Access Compliance Report

Public Rights-of-Way

(Curb Ramps)

Intersection ID: 3474	Main Street: W_W_T_HARRIS_BV	Cross Street: W_WT_HARRIS_TO_I-77_RA_NB	Location: SW
ADA ID: 8D23495F03EE	Ramp Type: Para	Initial Pass/Fail: Pass	Overall Compliance: No
Severity Score: 2.75			
Codes/Mitigation Info/Possible Solution		Field Measurements/Component Compliance

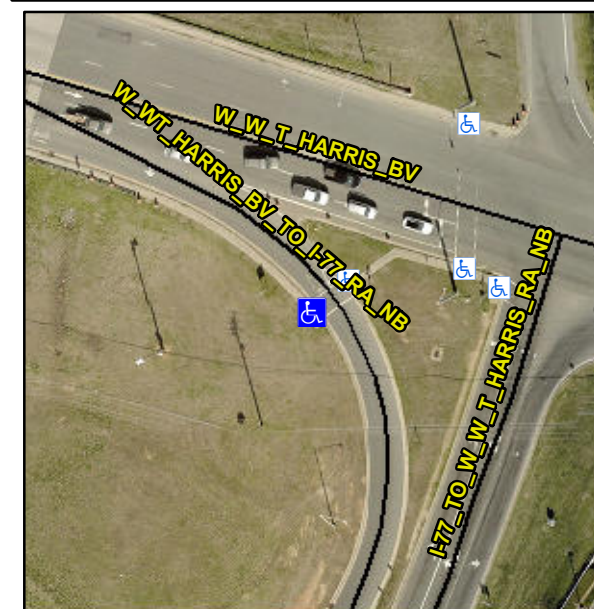
Surveyor Notes:

NO LT SW

PROW/ADA:

R304.5.3, R305.1.4, R305.2

Possible Solutions:

**Remove & Replace Entire Ramp.
Remove & Replace Gutter.**
